TECHNICAL INFORMATION

No: 76/02/01/NAS
Ref:
Issue: 1
Date: 03/02/01

Rear Center Seat Belt Escutcheon

Discovery Series II (LT)

Figure 1

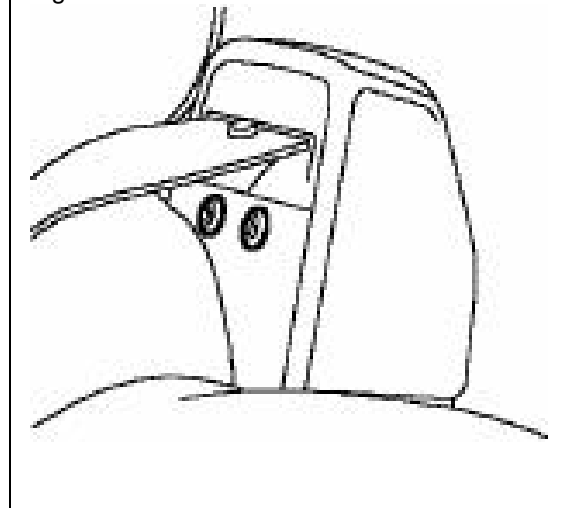
If allowed to return too quickly, the rear center seat belt "stop button" can pass through the opening of the escutcheon. Should the seat then be folded forward it is possible that the belt will jam requiring disassembly of the seat to release it from the folded position.

A new seat belt escutcheon has been introduced into production. The new part reduces the tendency of the seat belt "stop button" from passing through the escutcheon opening upon retraction. Repair of a locking seat belt complaint as described above should include replacement of the escutcheon with the new specification component. The new escutcheon is stronger to prevent the stop from passing through. The retraction force of the belt in current production has also been reduced.

1. Release the seat belt escutcheon from the center belt cover. (Figure 1)
2. Slide escutcheon off of the belt through the slot
3. Install new escutcheon onto the belt
4. Insert the escutcheon into the center belt cover.
